MONTHLY PROGRESS REPORT

KENDALL COUNTY

NEW OFFICE BUILDING

November Monthly Report

Curb Grading at West Lot Island

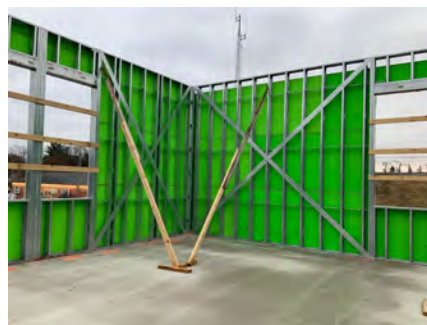
1. Verify the curb grading is correct at drive island in west parking lot, as it appears to be high.
2. Verify plan dimensions of metal stud framing at entry, as they do not appear to align equally with the steel beams.
3. Architect to verify locations of intermediate roof gutters along the East.
4. Verify exposed height of concrete light pole bases is 24".

1. Curb and gutter along west side drive, center island and north section, do not align. Confirm in field and further discussion is needed to remedy.
2. Steel beam along grid line 3 will need to be lowered to align with top of metal framing to allow trusses to span across per email from structural on 11/13/2023.
3. Steel angle on south west corner of entry appears to be bent, modify to be straight so it does not effect masonry veneer installation per detail 3/A6.4.
4. Coordinate electrical conduits for car chargers on south with masonry installation, and verify the conduit is out far enough so it does not cause conflict.
